Product Update

Modular Metering Global Product Manager:
Adam Busocker
R&D Manager: Heather LeBlanc
Document Number: 1TQC185500E0001, Rev A

Products Impacted: ReliaHome Meter Combo
SKUs (formerly Meter Socket Loadcenters)
Impact to Form/Fit/Function: Wingstab Removal
Issue Date: 1/28/2025

Figure 1: Wingstabs in old design (vertical stabs in red circles) will be removed in new product

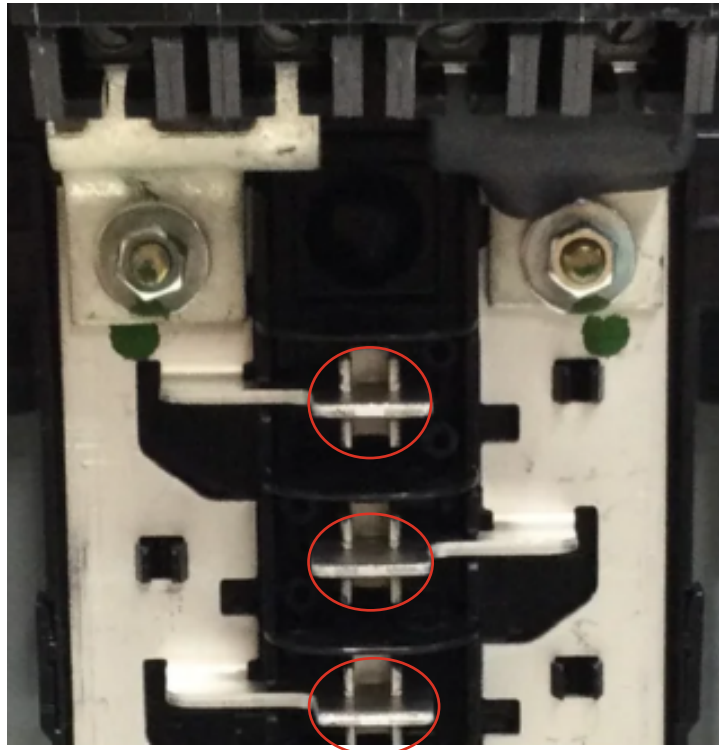
The purpose of this communication is to inform you about a product update for the following Relia-Home Meter Combo – Removal of wingstabs signified by a "Q" in the Nomenclature.

Removal of wingstabs continue to allow Tandems and Quad breakers to be utilized within this product group. However, the ReliaHome meter combo no longer accepts THQP breakers. All other aspects related for form, fit, and function are not changed. There are no impacts to utility approvals.
